UX30 PWR LED BD R1.1 Change List

Title : HISTORY

Size	Project Name	Rev
B	UX30 PWR LED BD	2.0

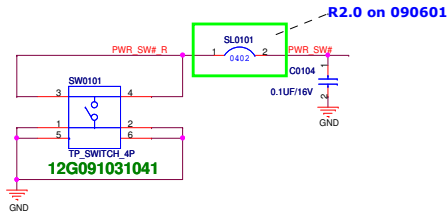
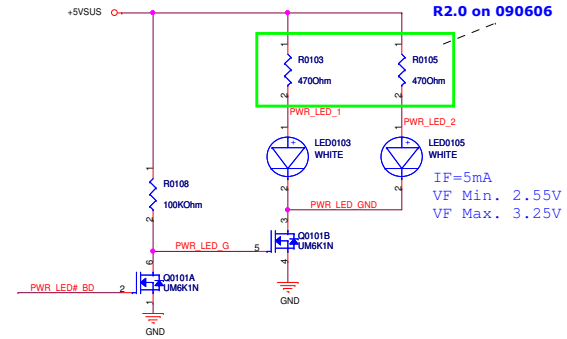
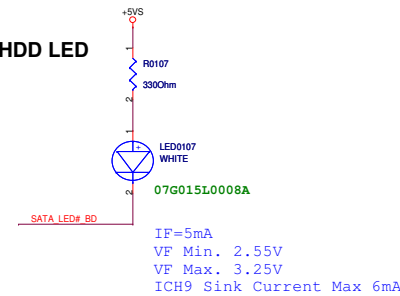
- 1. Change J0101 form 14 pin to 12 pin for ID change
- 2. Delete LED0105 , R0105 of Num Lock LED for PM Spec change
- 3. Delete LED0106 , R0106 of Wireless On LED for PM Spec change

- 1. Change J0101 Pin 3 from +5VSUS to +3VSUS
- 2. Change J0101 Pin 10 from +3VSUS to +3VA
- 3. Change U0101 Pin 1 from +3VSUS to +3VA

- 1. Delete R0109 and change to SL0101
- 2. Change R0103 and R0105 to discrease LED Light
